46860 WEST ROAD, JSP 17-35

Public hearing at the request of Quadrants Development for approval of Preliminary Site Plan, Wetland Permit, Woodland Permit and Storm Water Management Plan. The subject property is located in Section 4 of the City of Novi north of West Road and west of Hudson Drive. The applicant is proposing to construct a 36,000 square feet single story office and warehouse building with associated site improvements.

PLAN REVIEW CENTER REPORT

Revised Preliminary Site Plan

SHEET #
SD-1

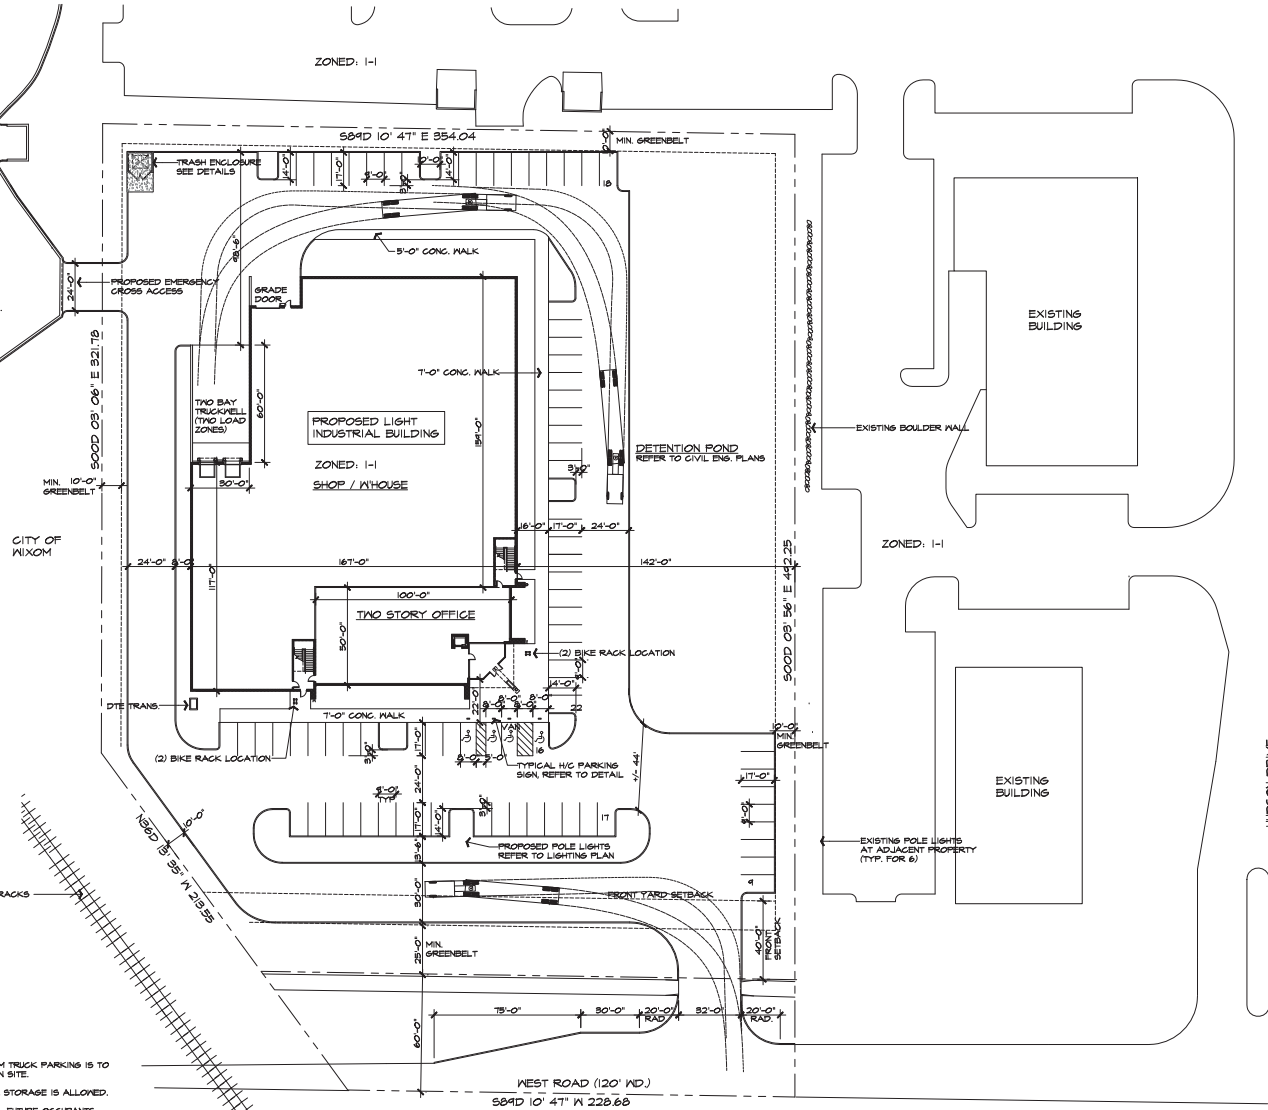
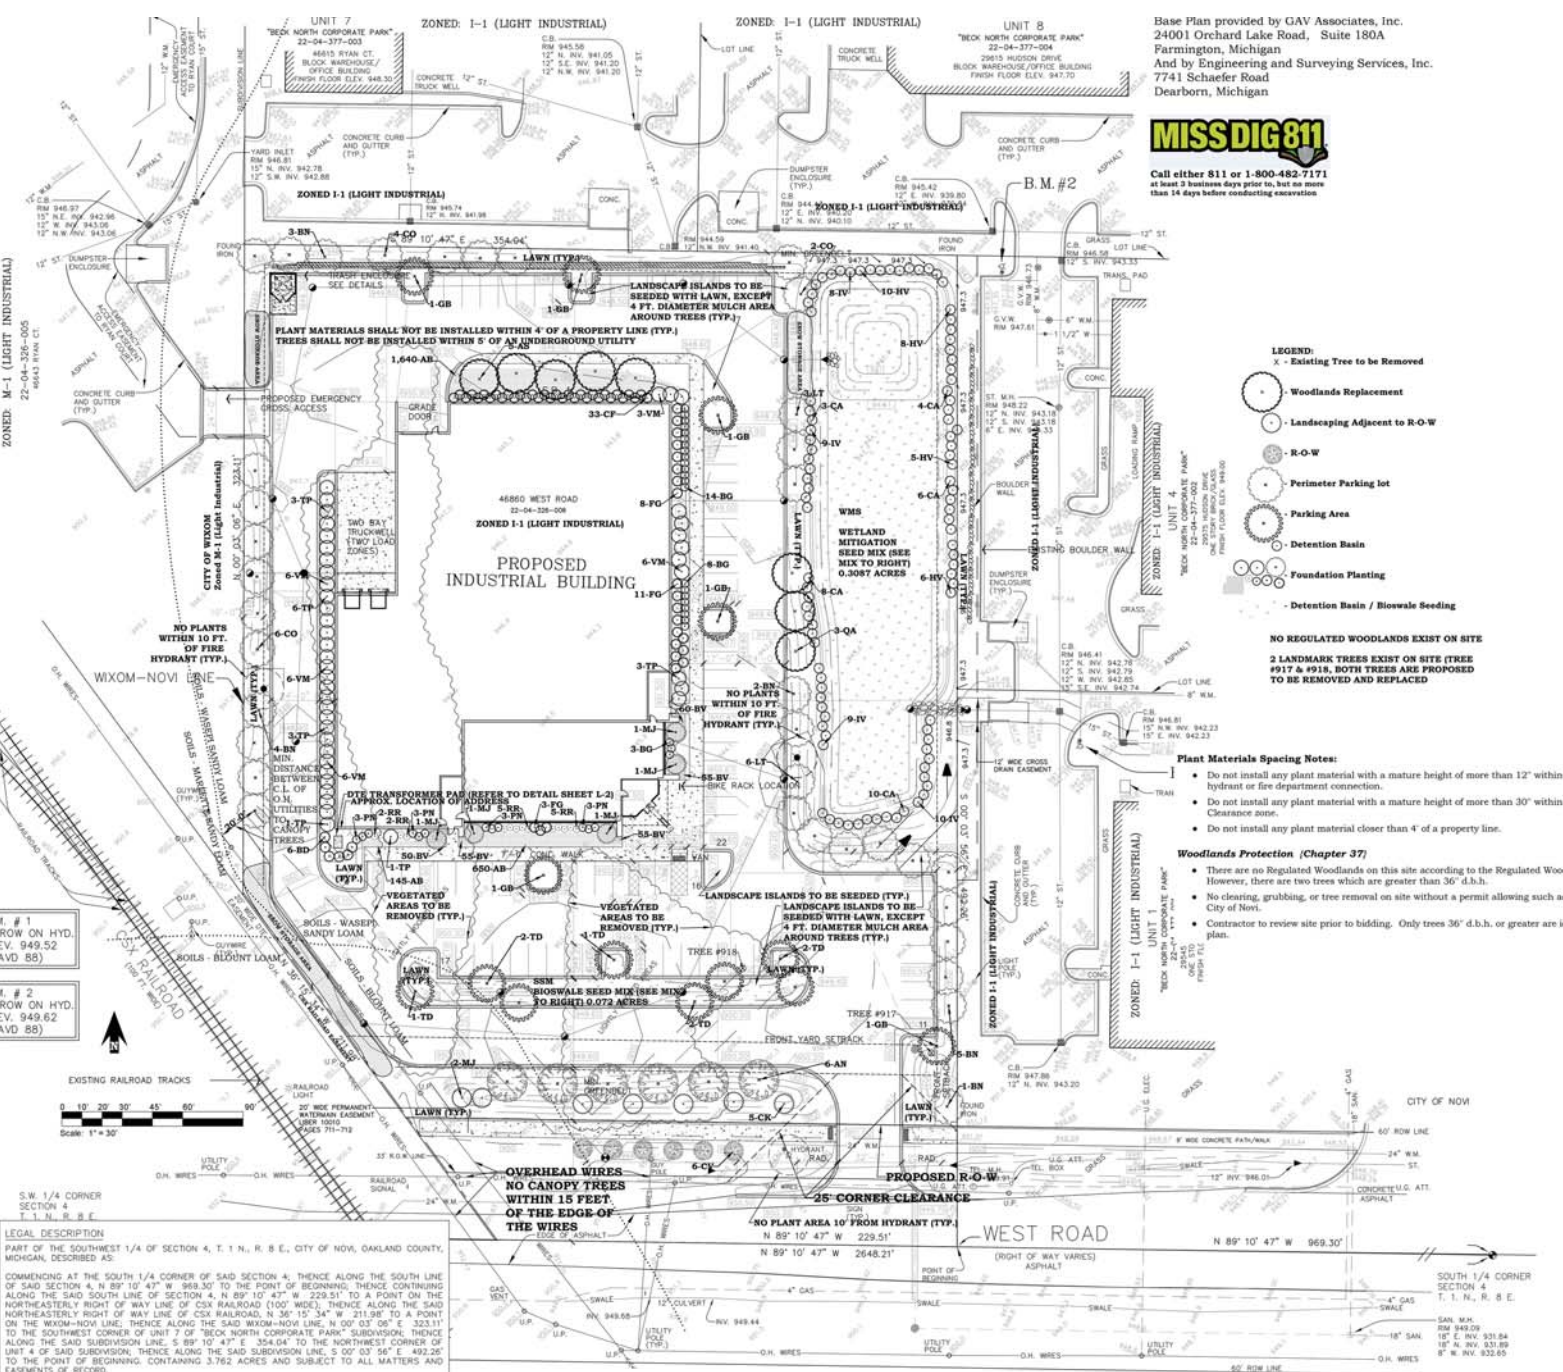
- ii. The applicant has provided a total of 84 parking spaces. The applicant should revise the parking table on sheet SD-1 to indicate 84 spaces and not 83 total spaces.

A note shall be added to sheet SD-1 for the prohibiting of retail sales to the consumer.

DRAWN :	DESIGNED :	CHECKED :
SCALE :	FILE NAME :	JOB # : 16151
SHEET TITLE		
EXTERIOR ELEVATION		
SHEET #		
A.201

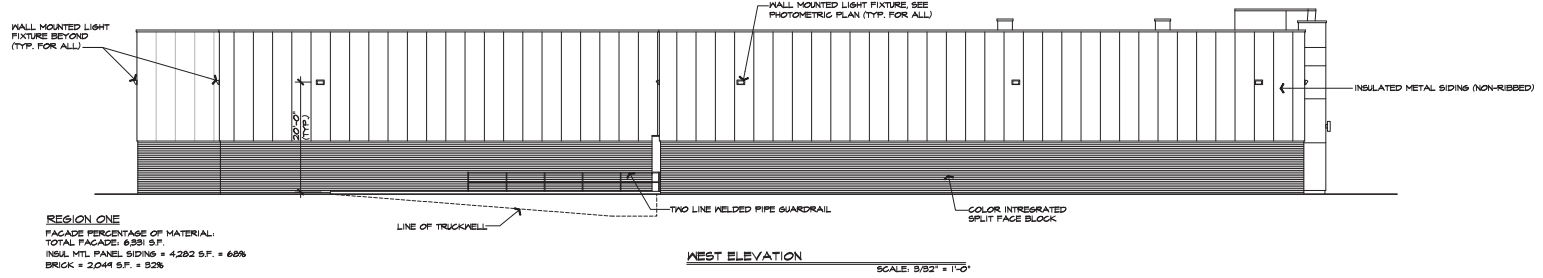
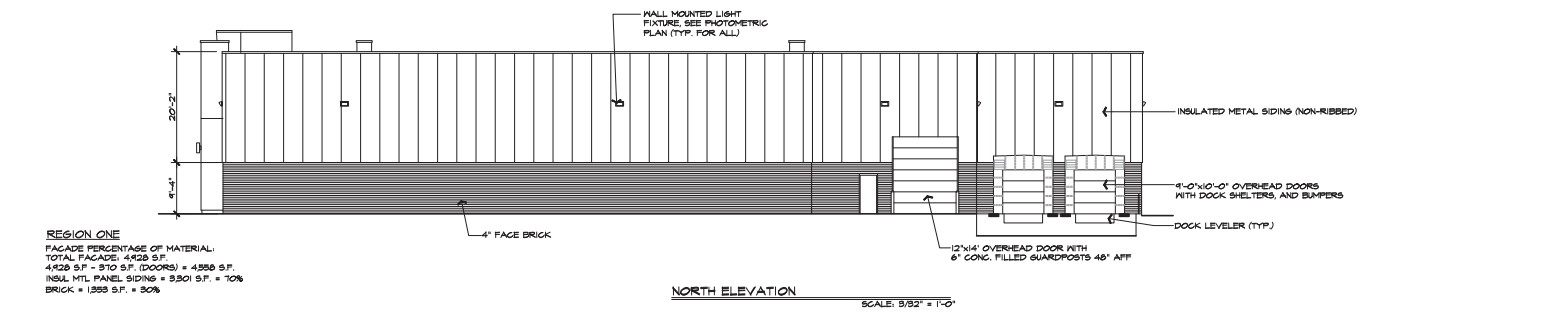
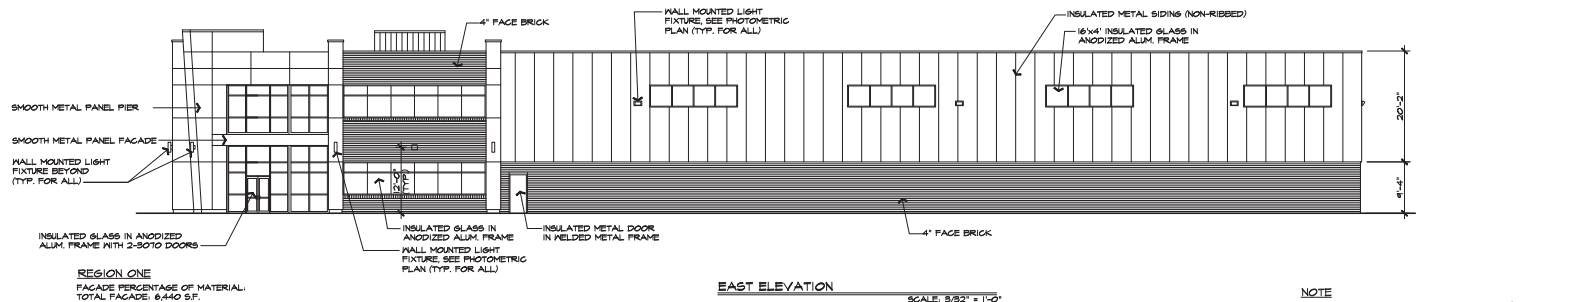
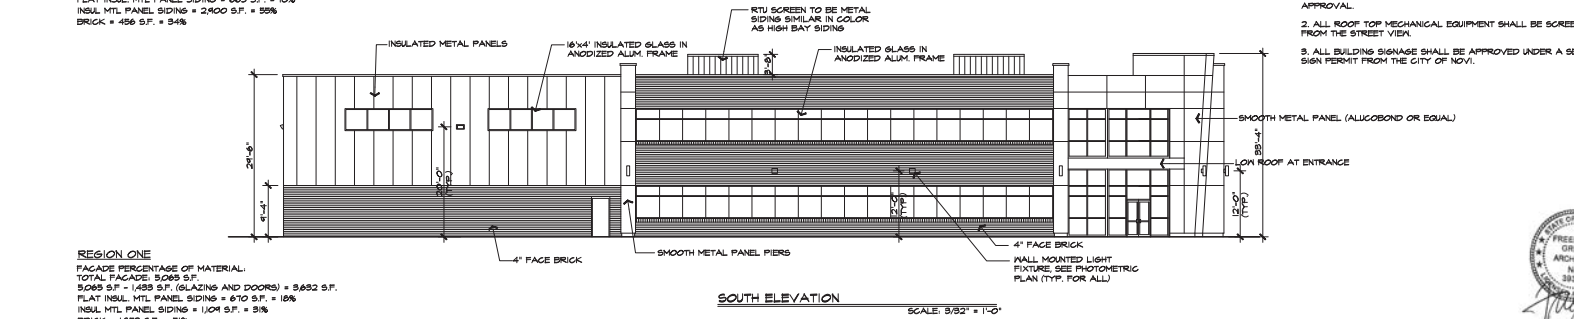
Facade	Approval Recommended	2-13-18	<ul style="list-style-type: none"> • Section 9 waiver required for exceeding maximum allowable percentages for flat metal panels on the West and North elevations. Staff supported.
Fire	Approval recommended	11-16-17	<ul style="list-style-type: none"> • Items to be addressed on Final Site Plan

- a. To allow the overage of Flat Metal Panels (50% allowed; 70% on north, 68% on west), because those elevations have a lower degree of visibility from the major thoroughfare and overall the building is consistent with the intent and purpose of the Façade Ordinance, which is hereby granted;
- b. The applicant will either seek a Zoning Board of Appeals variance for the proposed transformer in the front yard or propose permanent screening to comply with the Zoning Ordinance requirements;
- c. The conditions and items listed in the staff and consultant review letters being addressed on the Final Site Plan; and
- d. *(additional conditions here if any)*
